World Forum for Harmonization of Vehicle Regulations

Proposal for Corrigendum 1 to Revision 6 of Regulation No. 37 (Filament lamps)

Note by the secretariat *

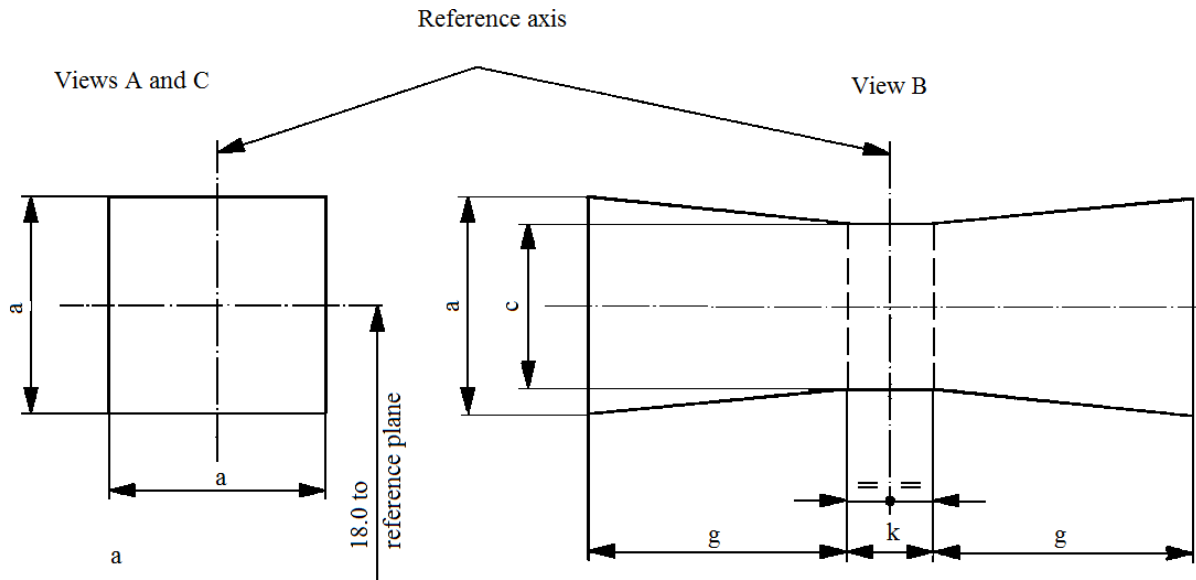
Sheet H1/1, the drawing, View C, replace the designated angle "€" by 'ε', as follows:

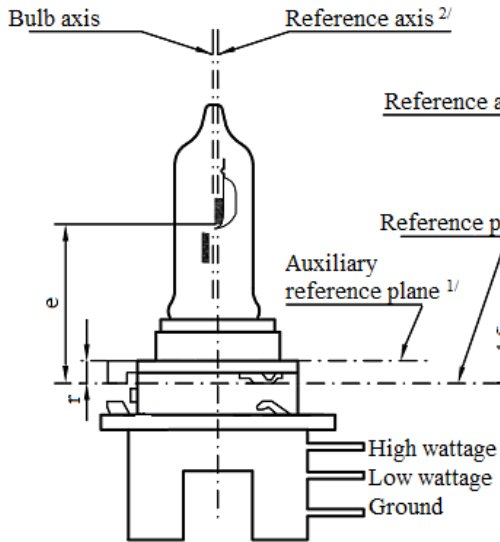
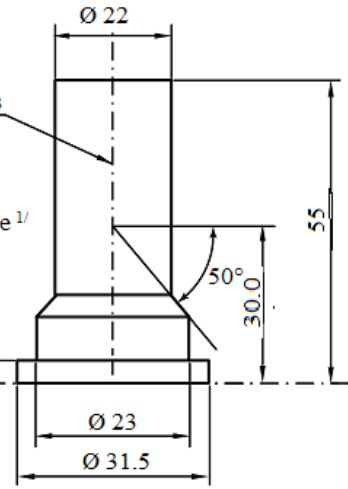
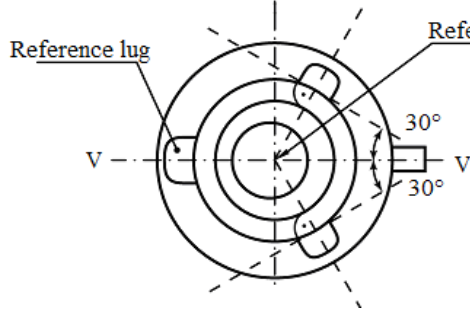
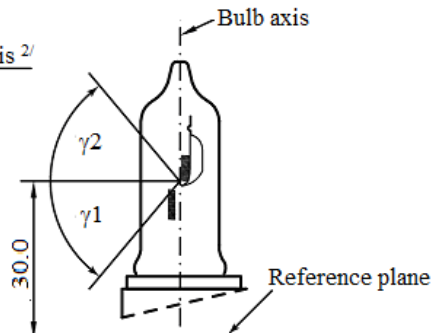
Sheet H15/1, the drawings, Figure 2, move up the parameter "V"; Figure 3, move up the value "4.5"; Figure 4, move up the parameters " γ_1 " and " γ_2 ", as follows:

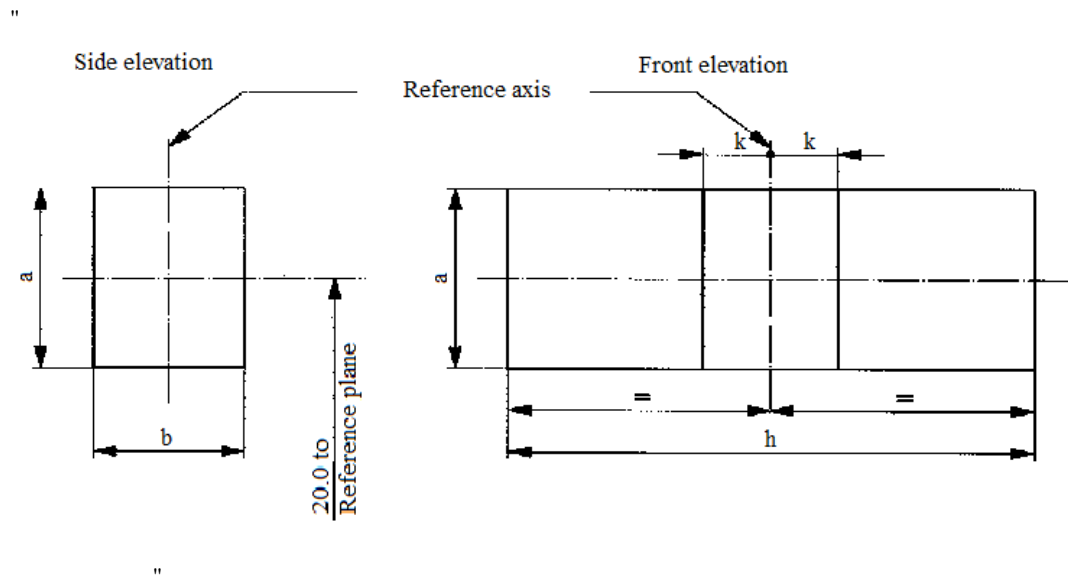
Sheet H21W/1, the table, the last row, lower the line to reveal the reference luminous flux value for "amber: 300 lm", to read:

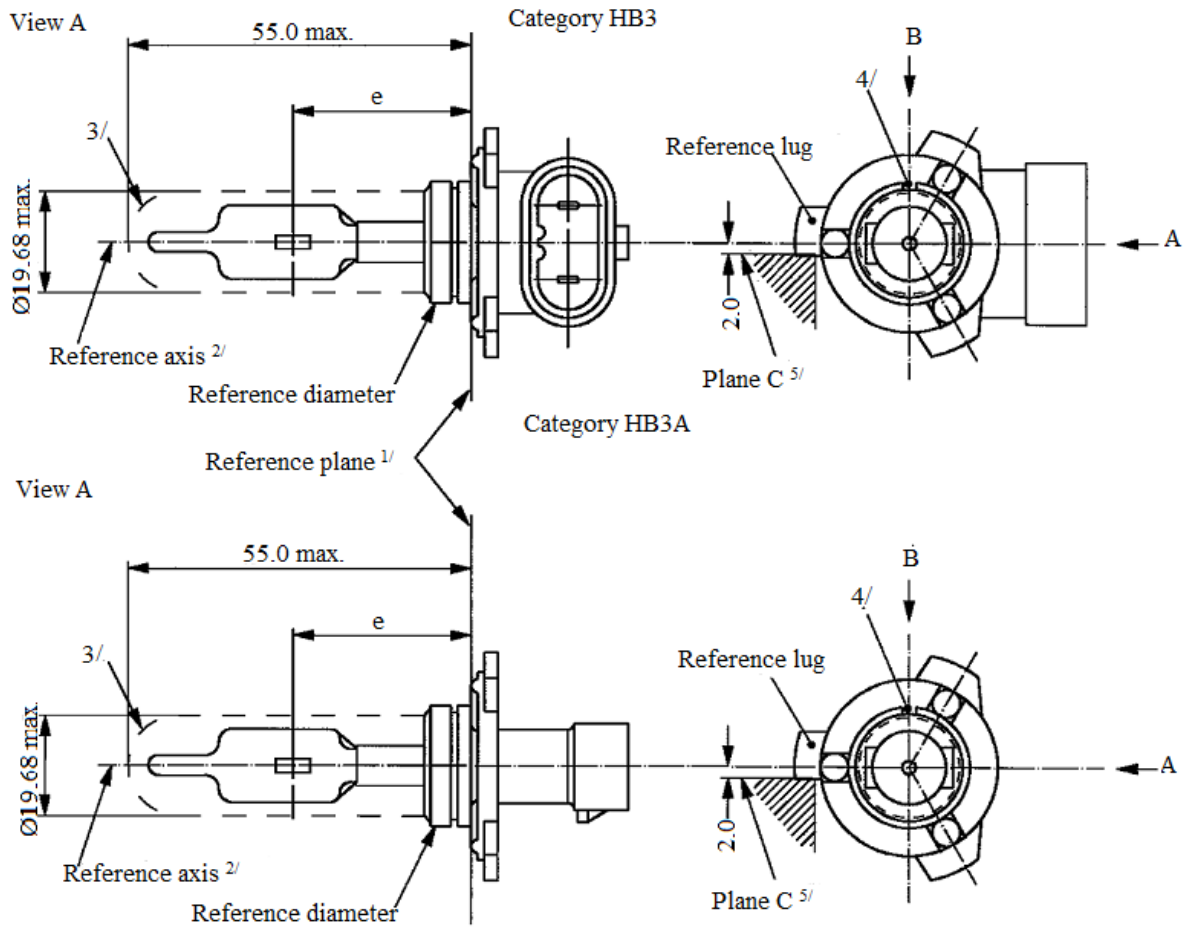
Sheet H21W/2, the drawing, the vertical aligned text, replace "20.2 Reference axis" by "20.0 to Reference plane", as follows:

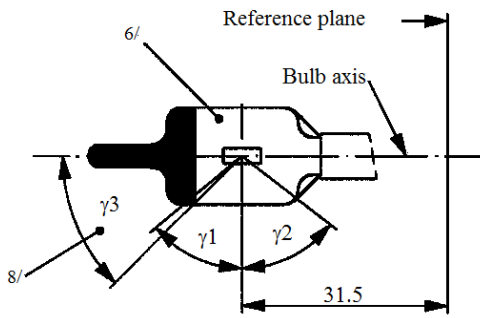
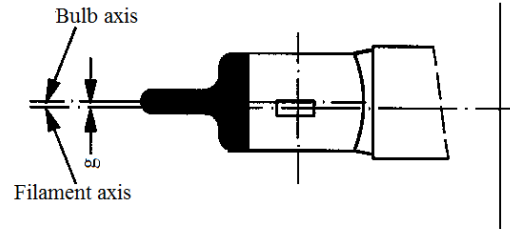
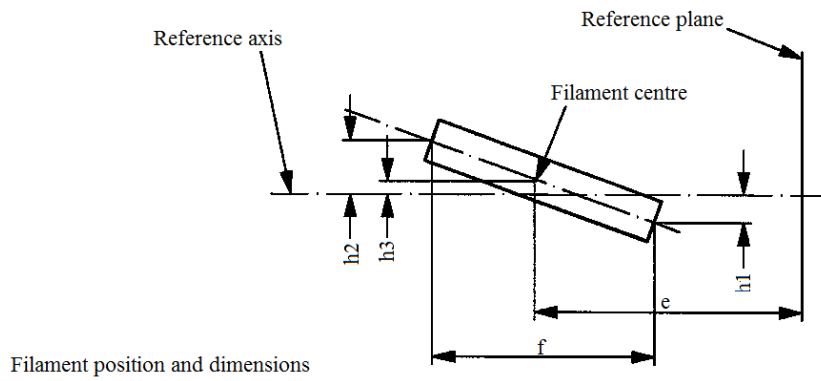
Sheet HB4/2, the note to γ_3 , replace the 2nd note 6/ by note 8/, as follows:

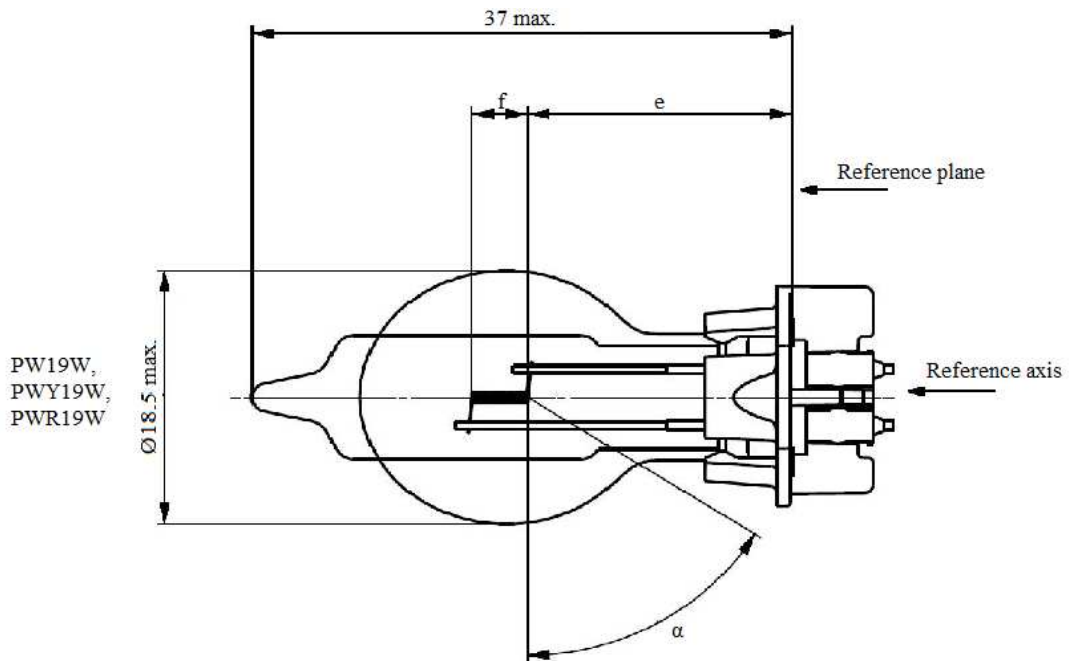
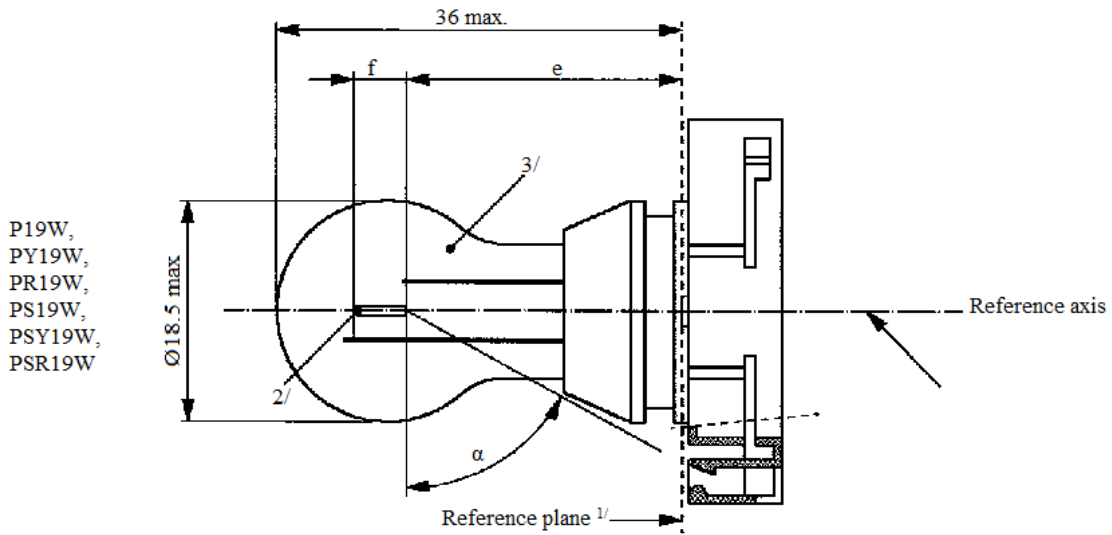
Sheet P19W/1, the lower drawing, insert the missing symbol "α", to read:

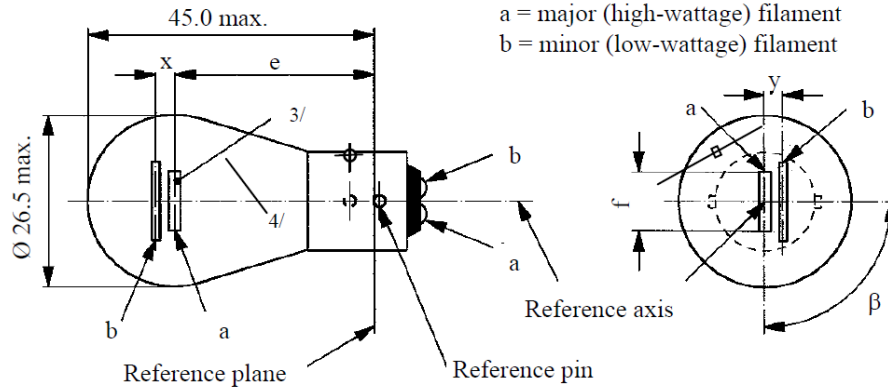
Sheet PR21/5W/1, the dimension in the drawing left top, replace the value "55.0 max." by "45.0 max" (as in Revision 5 of the Regulation), as follows:

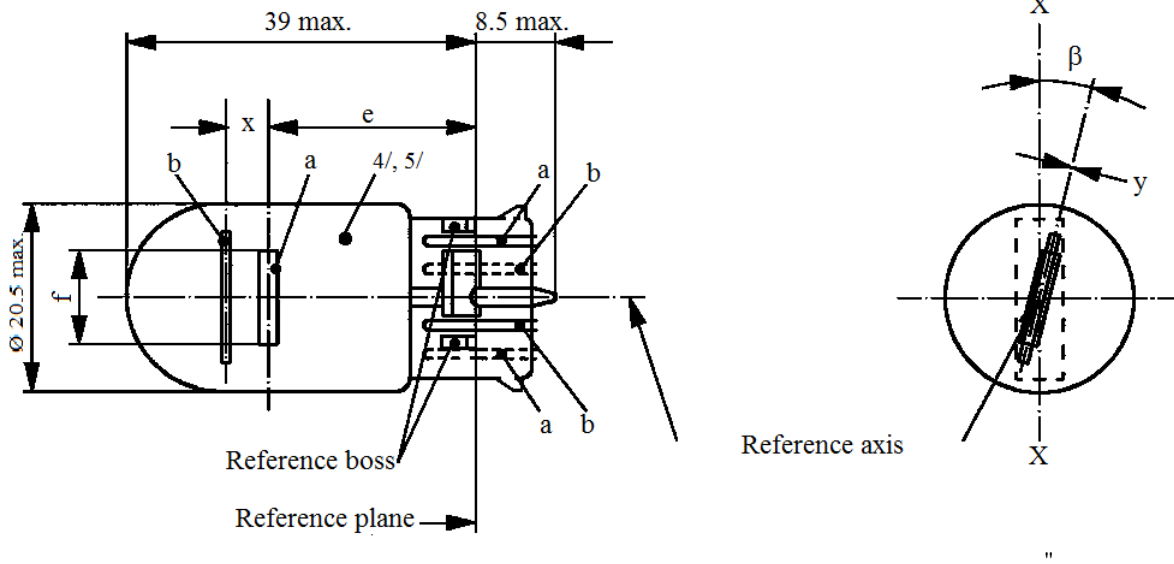
Sheet WR21/5W/1, the drawing, correct to read:

"a = major (high wattage) filament
b = minor (low wattage) filament

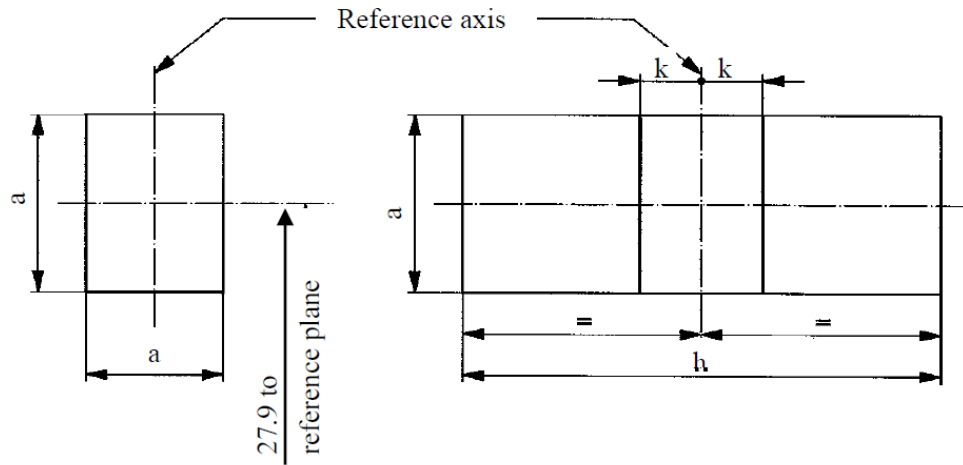
Sheet WY21W/2, the drawing, bottom line, left, replace the parameter "a" by "b", to read:
